ADDENDUM No. 1

ITB No. 4754

Fiber and Conduit Construction for the Ann Arbor/Ypsilanti Broadband Project

Map showing connection points and path to Data Center.

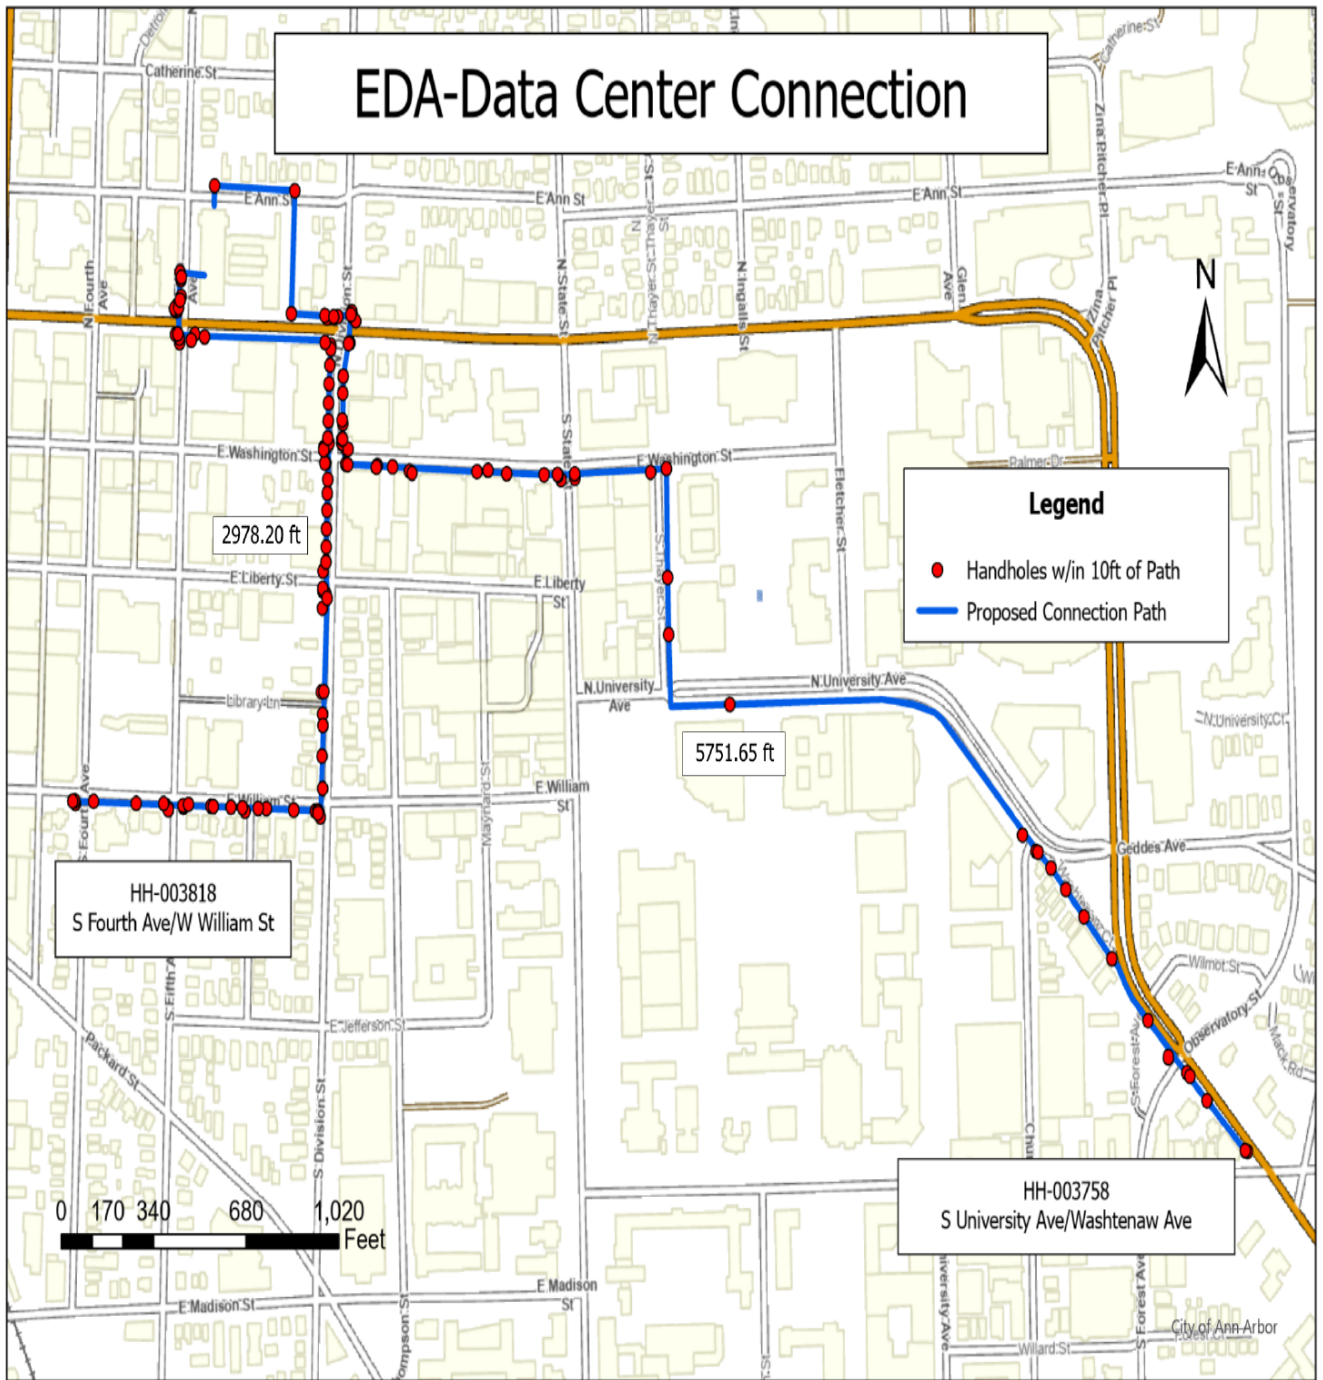
Question 14: How many total existing handhole (HH) locations will be intercepted for the new fiber build, and how many of these locations will require upgrades to accommodate the new ducts?

Question 25: Do we have drawings of where the fibers are going from last handholes at each end?

Answer 14: The new conduit system will intercept each handhole and utilize existing conduit back to the data center. The handholes and conduit was installed within the last 2 years. See attached map on page Addendum-1-8.

Answer 25: Yes, please see attached map on page Addendum-1-8
